RE: Planning Commission Advisory Report
Ordinance No.: 2021-416 **Application for: San Pablo Road South PUD**

REPORT OF THE PLANNING AND DEVELOPMENT DEPARTMENT FOR

APPLICATION FOR REZONING ORDINANCE 2021-416 TO

Revised South San Pablo Parkway PUD

CONCEPT PLAN
OLEA AT SAN PABLO
 3/29/21

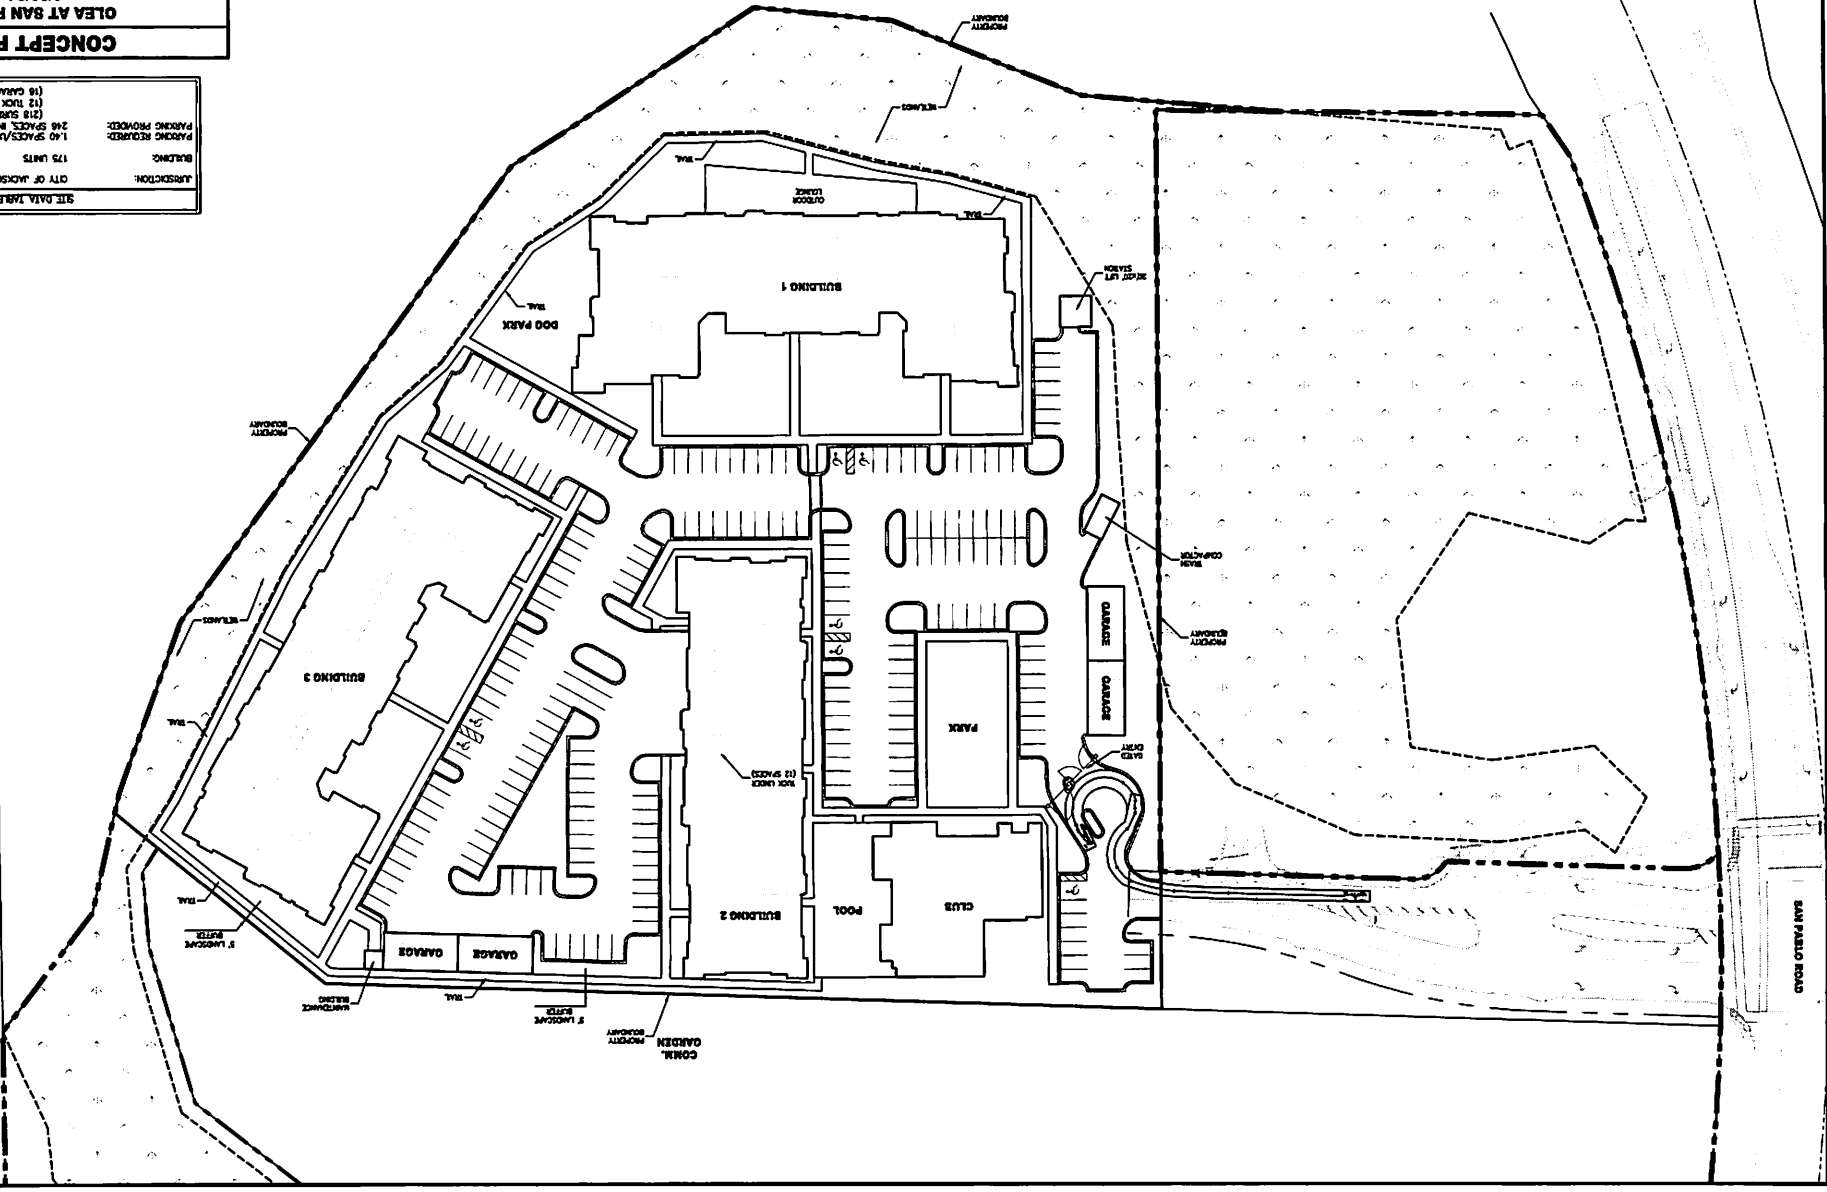
The applicant has stated in their application that “Required parking ratio shall be 1.35 spaces per unit. No parking for bicycles or loading spaces shall be required.” The Department does not support this deviation from code. Pursuant to Policy 4.1.5 of the Transportation Element of the 2030 Comprehensive Plan, the applicant must provide for the convenient and safe access by and securing of bicycles on site. The bicycle parking must be consistent with the requirements outlined in Part 6 of the Zoning Code.

Comments from the Transportation Planning Division are as follows: Deviation from Section 656.605 shall not be permitted. Vehicular parking ratio, required bicycle, and loading spaces are required per Part 6 of the Zoning Code.

Comments and suggested edits about the proposed parking ratio within the Written Description of the PUD were sent to the applicant on June 10, 2021. Staff finds with the Transportation Planning Division that the proposed 1.35 parking spaces is not sufficient for a project of this size and location.

- 1) Lot coverage will be a maximum of 50%, consistent with RMD-D.
- 2) Pursuant to Policy 4.1.5 of the Transportation Element of the 2030 Comprehensive Plan, the applicant must provide for the convenient and safe access by and securing of bicycles on site. The bicycle parking must be consistent with the requirements outlined in Part 6 of the Zoning Code.
- 3) Vehicular parking ratio, required bicycle, and loading spaces are required per Part 6 of the Zoning Code.
